Discontinuation Notification

To: Global Micro Motion Customers
cc: Global Micro Motion Sales
From: Tonya Wyatt
Date: June 25, 2010
Subject: Product Discontinuance – Analog RFT9739 Rack and Field Mount Transmitters

Replacement of RFT9739E/D (field mount version) with 9739 with MVD Technology

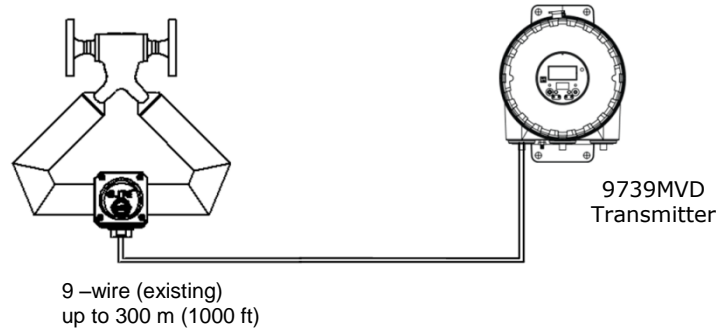
A **retrofit kit** can be used if:

- the existing transmitter model number starts with RFT9739D4, RFT9739D5, RFT9739E4, or RFT9739E5
- the existing transmitter serial number begins with 17, 18, 2, or 7.

A **complete transmitter** is required if:

- the existing transmitter model number starts with RFT9739E1, RFT9739E2, or RFT9739E3
 - the existing transmitter serial number begins with 15.
-

Replacement of RFT9739E/D (field mount version) with 2700 with MVD Technology

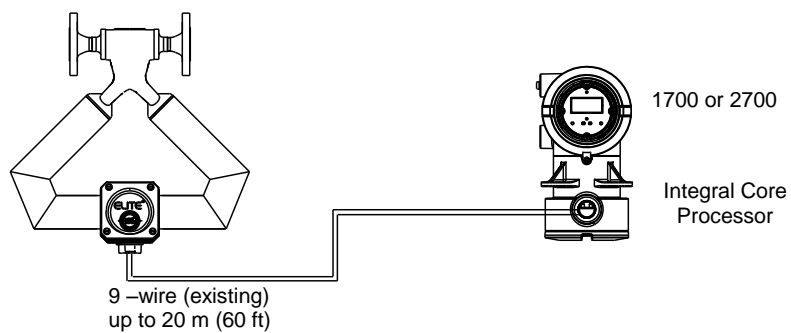
The Micro Motion 9739 with MVD provides a simple and cost effective electronics module upgrade solution compatible with any 9-wire Micro Motion sensor. **The 9739 with MVD upgrade kit will provide a direct replacement of the Analog RFT9739 electronics module while using the existing electronics housing, wiring and conduit connections.** It is a plug and play replacement with the same inputs and outputs and the identical wiring distances as the Analog RFT9739 transmitter. Additionally, it completely replaces all of the electronic components of the existing transmitter including the power supply. Alternatively, a Model 2700 MVD transmitter could be used to replace the existing analog RFT9739 (see page 3).

Replacement of RFT9739R (Rack mount version) with 2500 with MVD Technology

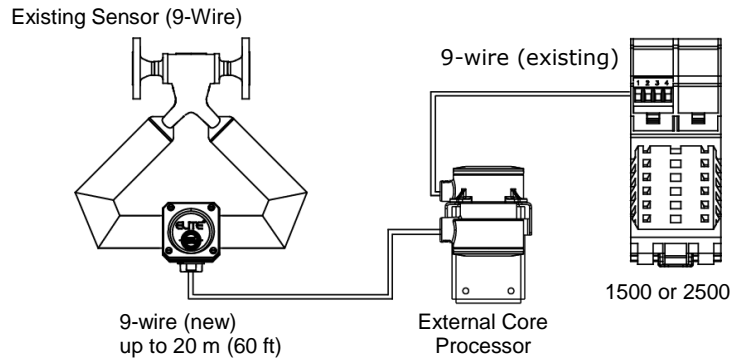
If you would like to continue to have your electronics installed in a control room, Emerson offers the Micro Motion Model 3500 MVD transmitter (Rack mounted with display) as well as Model 2500 MVD transmitter (DIN Rail mounted without display). Either option will require the addition of a core processor which can be remotely mounted to an existing Micro Motion 9-wire sensor (see page 4).
